ADDENDUM A
SOLICITATION #3450004900 / 20-FM-0042
01/31/2020

ODOT DIVISION V
BECKHAM COUNTY MAINTENANCE YARD
(SAYRE, OK)

This addendum contains corrections to the project specifications and plans.

Project: Oklahoma Department of Transportation – Beckham County Maintenance Facility
Location: Sayre, Oklahoma
Issued Date: 30 January 2020

SHEET
C2.1

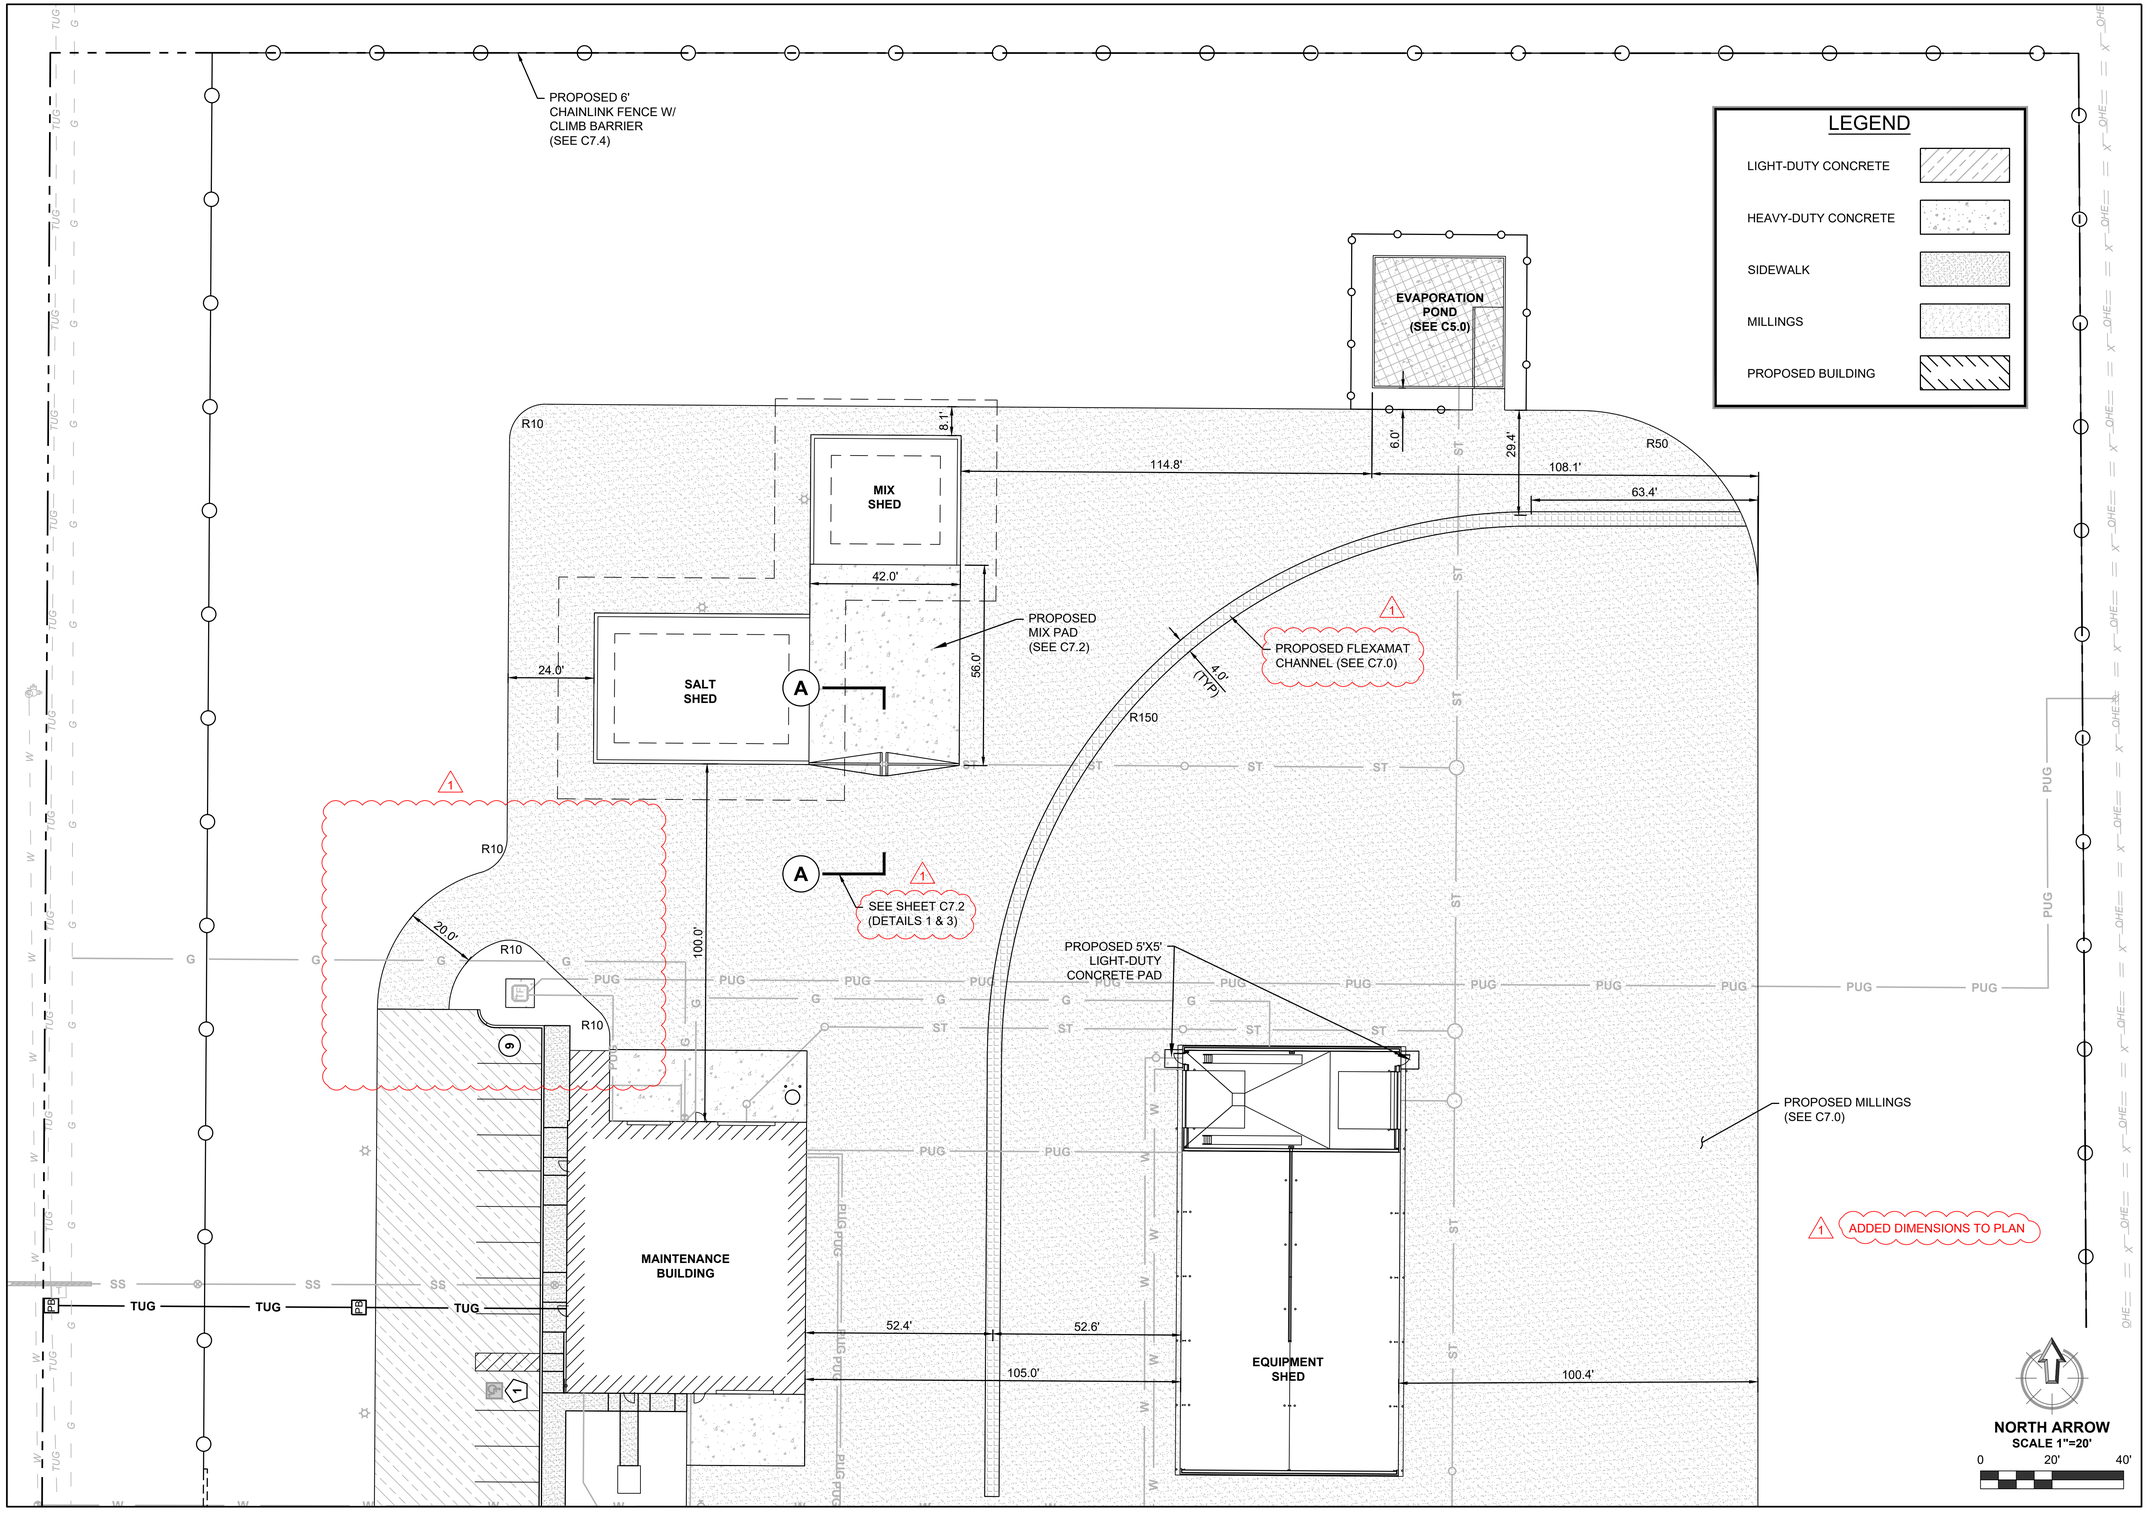
SHEETS C2.1, C2.3, C2.4, & C3.1 Replace sheets with attached; revised parking lot layout to remove west curb, widen stalls, & allow for fire-truck pull-through; narrowed entry gate; changed trickle channel to flexamat

SHEET
C3.2

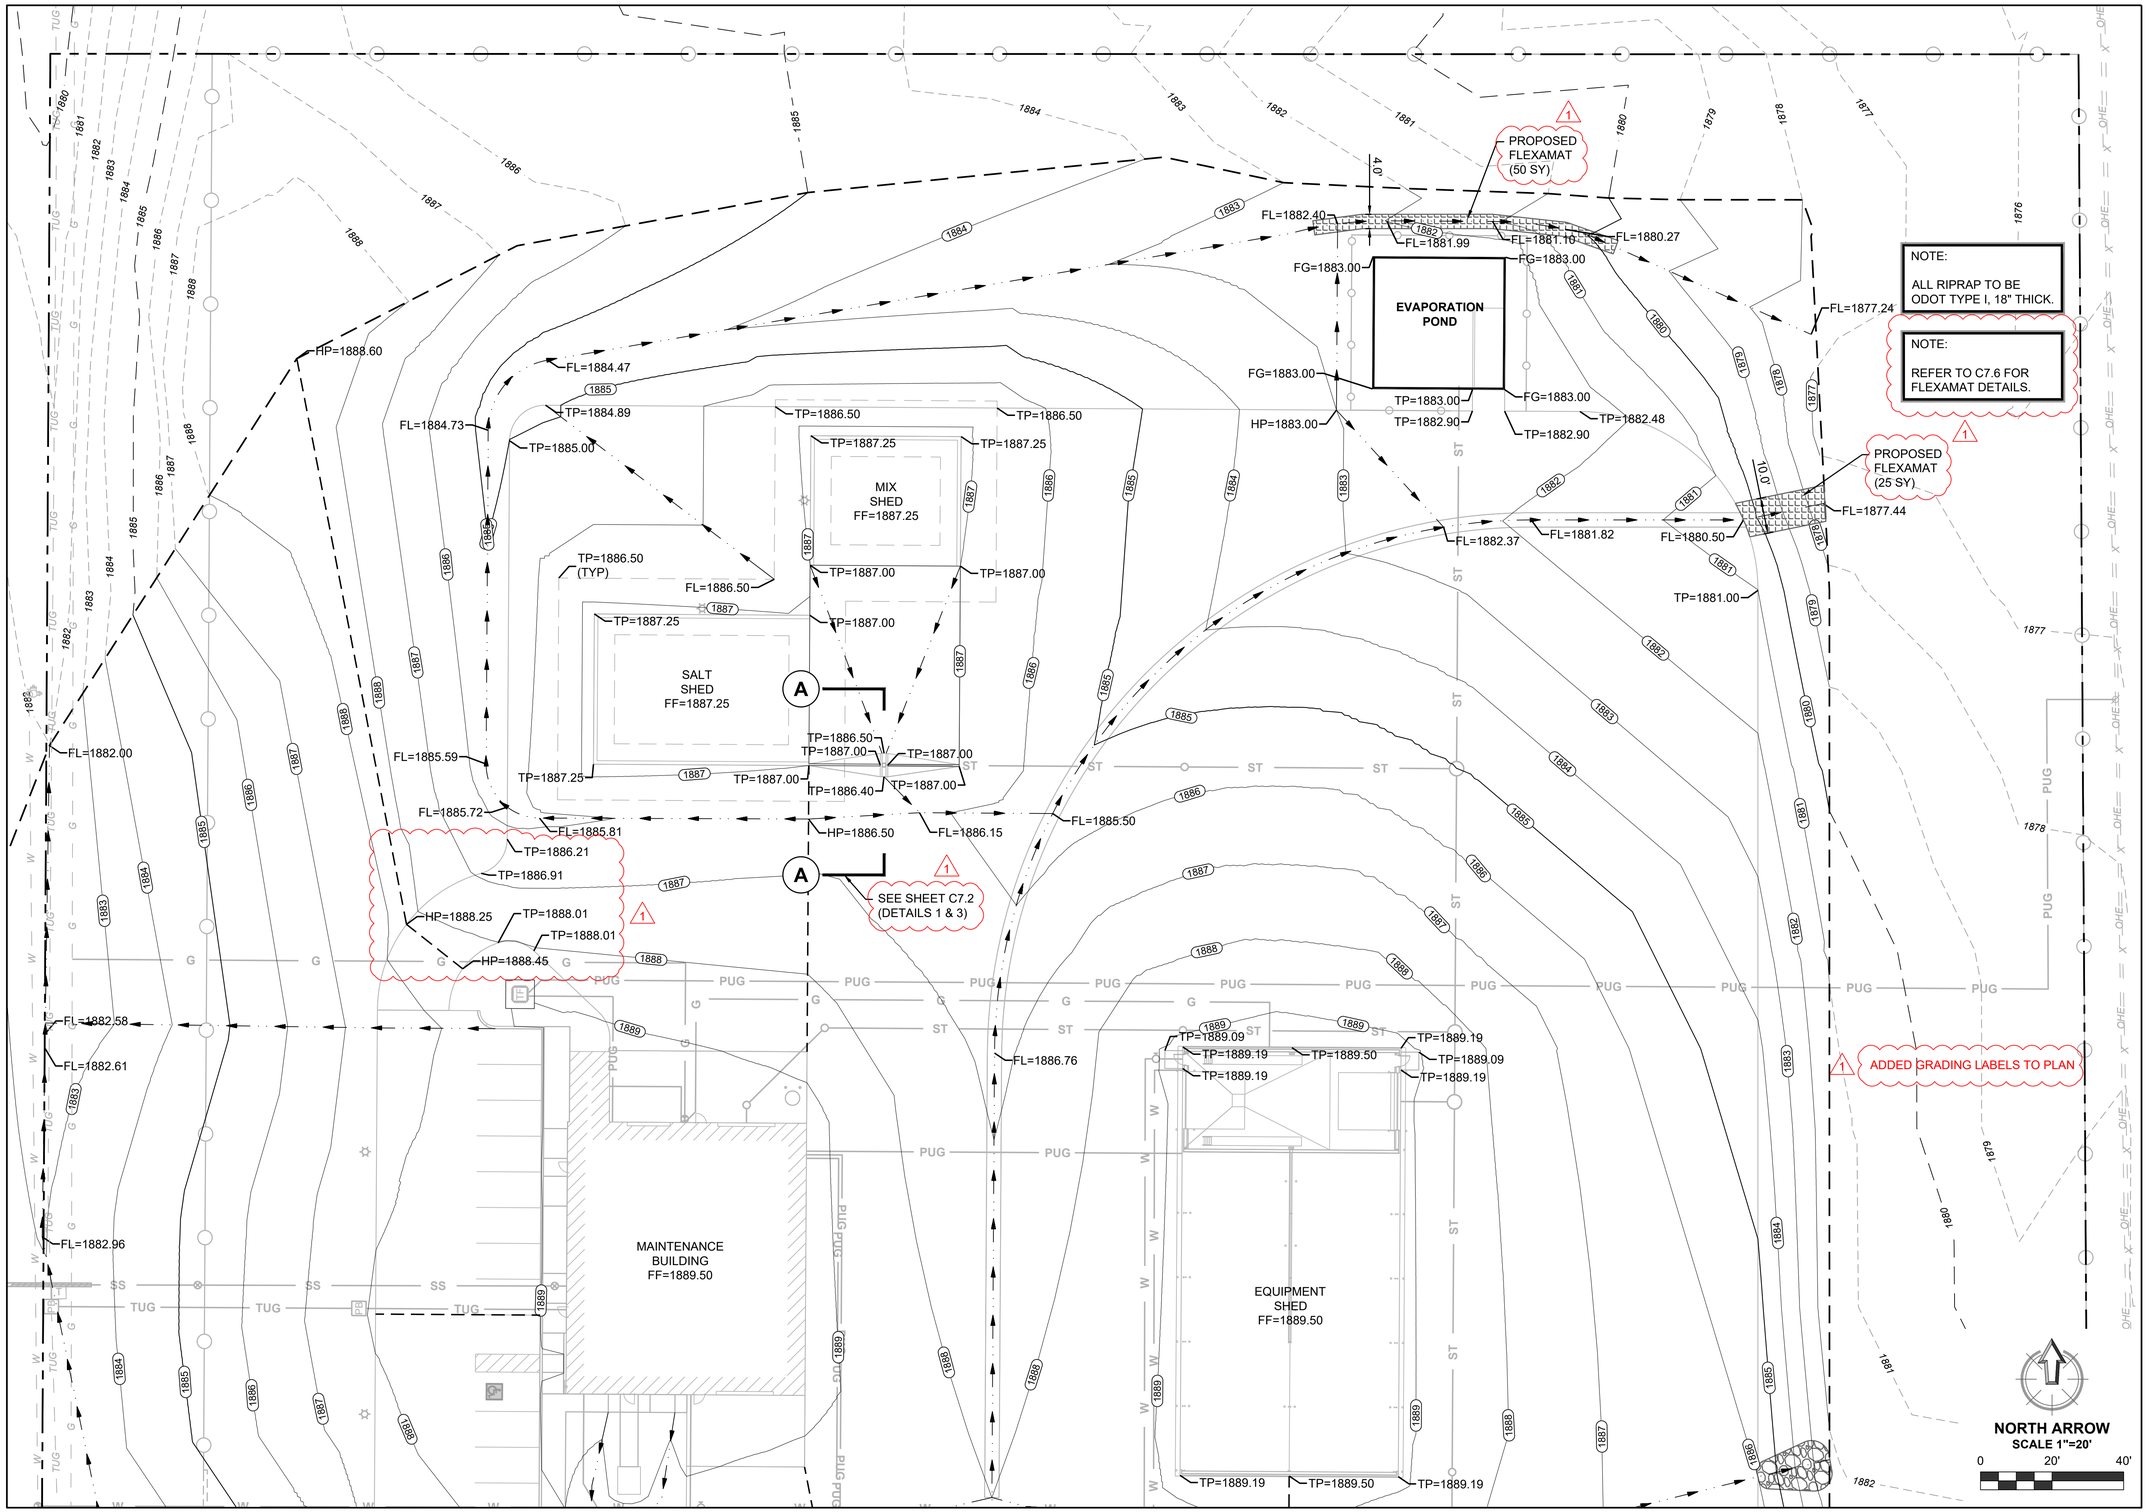
SHEETS C3.2 & C3.3 Replace sheets with attached; revised/added grading labels at fuel tank & salt/mix shed; changed several rip-rap areas to Flexamat

SHEET
C4.0

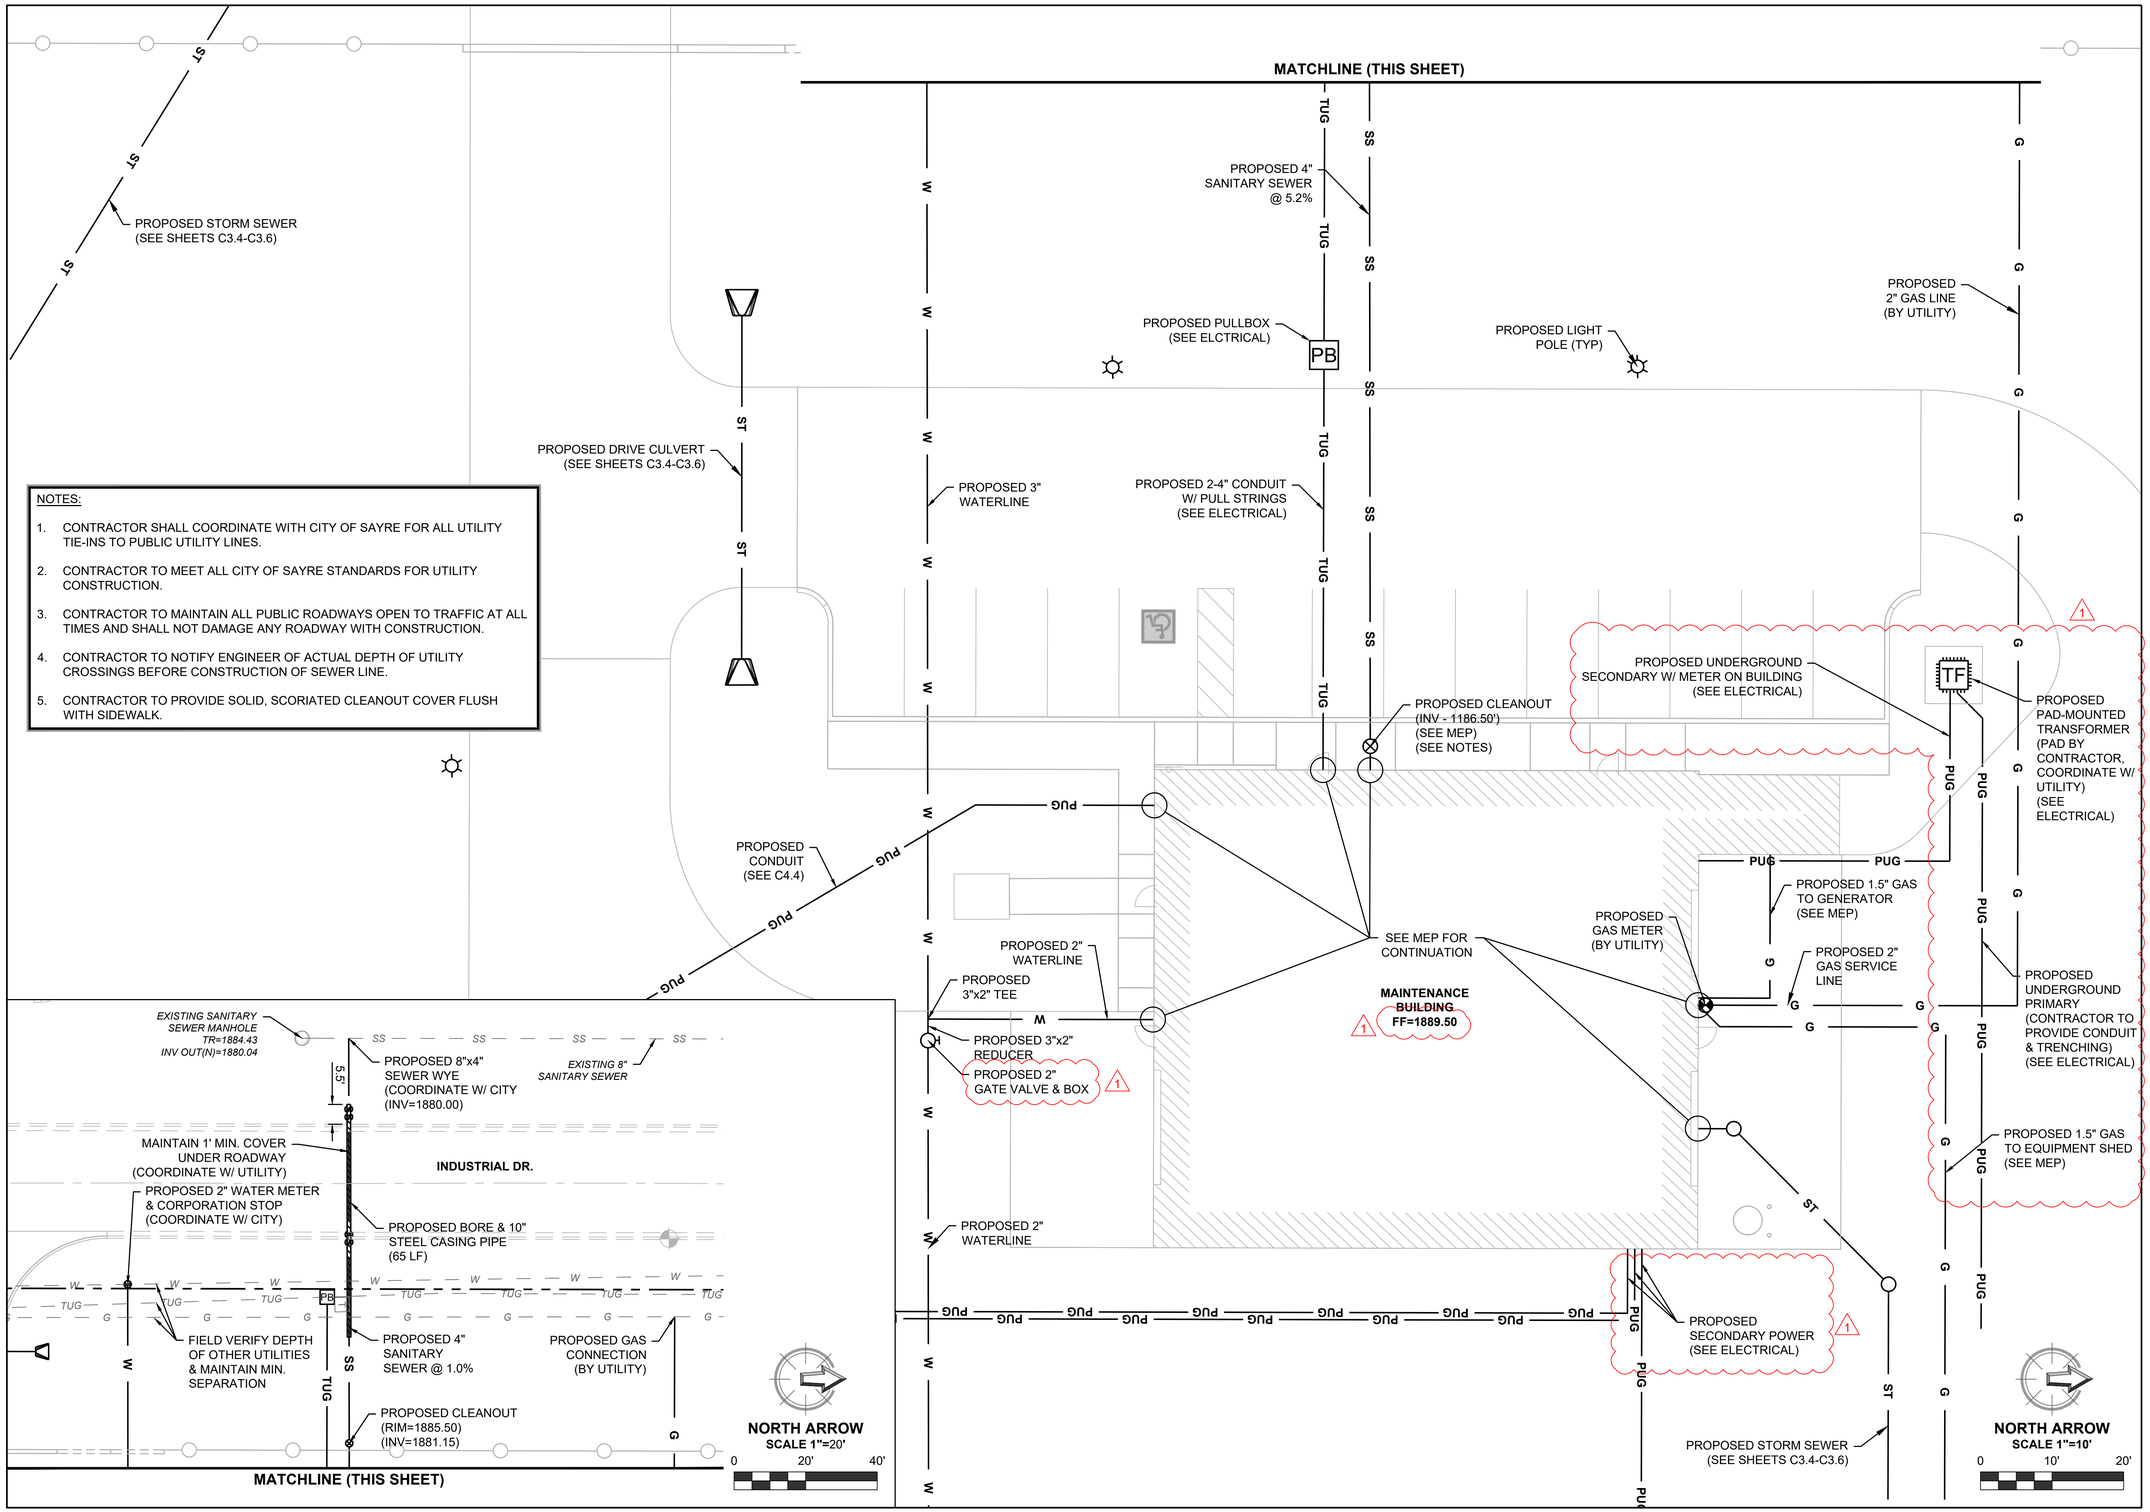
SHEETS C4.0, C4.1, C4.2, & C4.3 Replace sheets with attached; revised waterline sizes & added fill hydrant at hopper rack; revised electric pathways
